Construction Division
Additions & Alteration Charges Approval Form

Quality Control Check Report. Stage: After Finishing Stage II (Apartments)

Details of Additions & Alterations

Flat No	503	Block no.	' G '
Flat Area	1360 sft	Type	Deluxe / Luxury
Buyer Name	Atulesh Kumar		
Phone No.	9963022011	Email

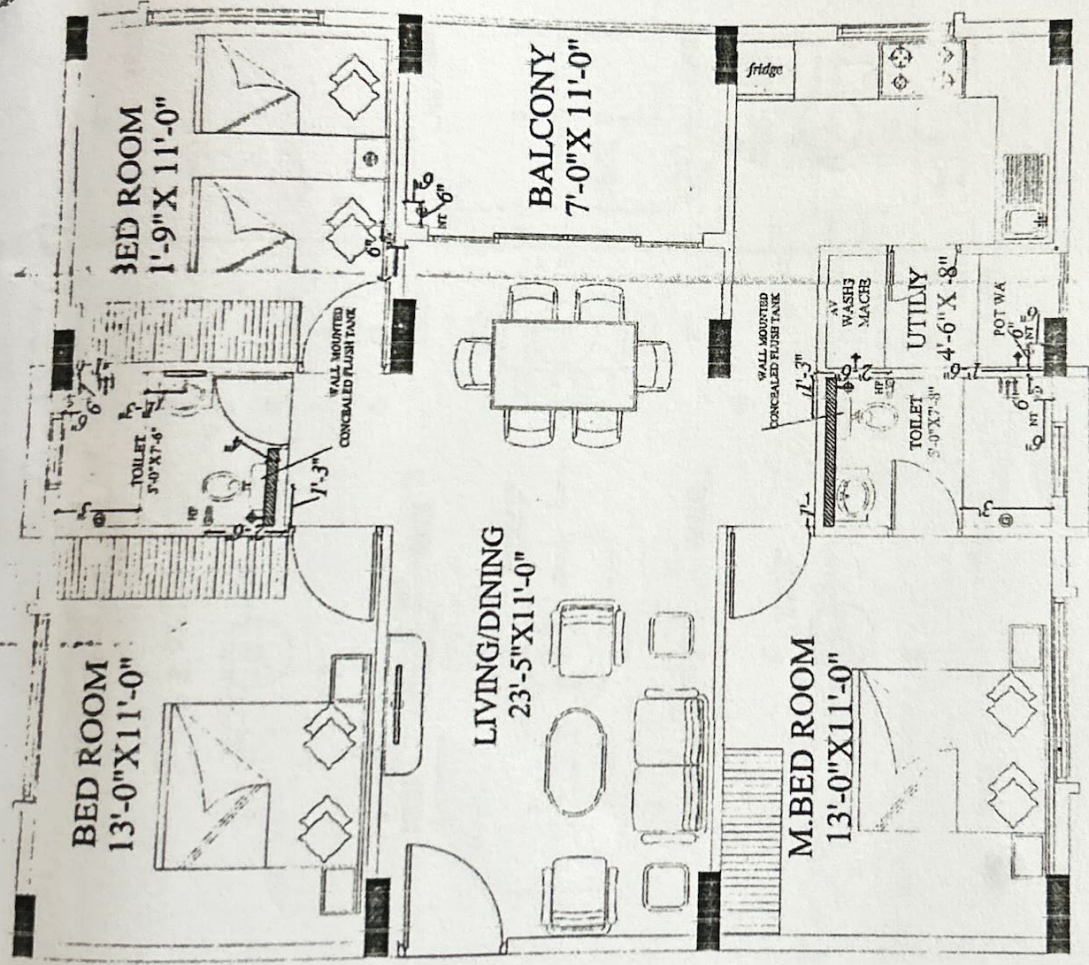
G-503 plumb

Direction: N
Description: QC-A-BLOCK-ELECTRICAL PLAN-1360 sq ft FLATS-A2 TYPE

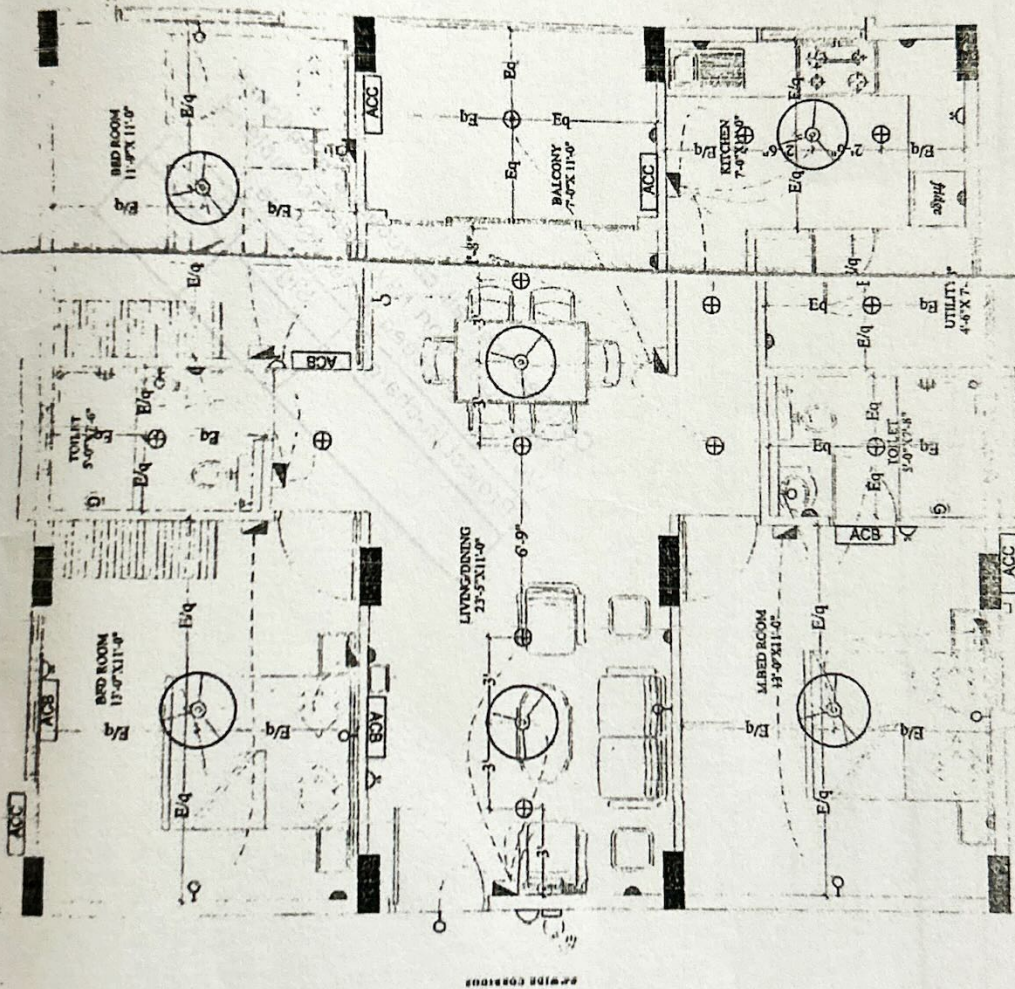
G1-503 (He)
